FEAD—BELT TENSIONER WEAR—VEHICLES WITH 7.3L DI TURBO ENGINE

Article No.
98-23-14

FORD: 1995-1997 F SUPER DUTY
1995-1998 ECONOLINE, F-250 HD, F-350

Figure 1 - Article 98-23-14

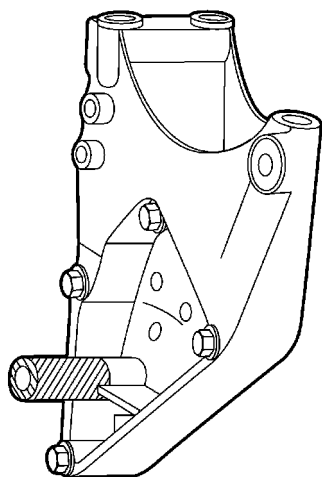
CUT BOSS FLUSH WITH SIDE OF BRACKET

1. Remove drive belt, alternator, belt tensioner, grooved idler pulley, flat idler pulley, and alternator mounting bracket.
2. Modify the alternator mounting bracket as follows:
 - a. Cut off the support boss for the grooved idler pulley. The boss must be cut off flush with the side of the bracket support ribs (Figure 1).
 - b. Cut the boss support rib down 12mm (0.5") from the boss to support rib of the bracket (Figure 2).
 - c. Modified bracket should appear as in Figure 3.

Figure 2 - Article 98-23-14

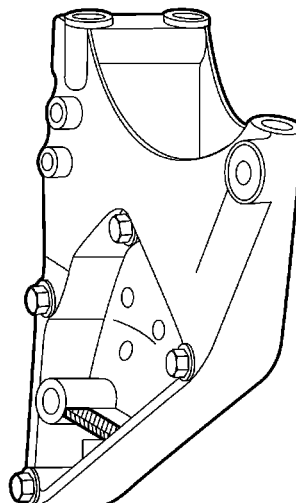
CUT SUPPORT RIB 12mm (0.5")
FROM THE BOSS TO SUPPORT RIB OF BRACKET

Figure 3 - Article 98-23-14

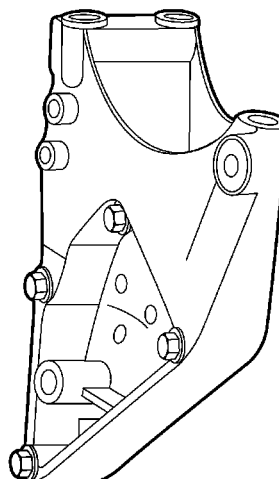
FINAL MODIFIED BRACKET
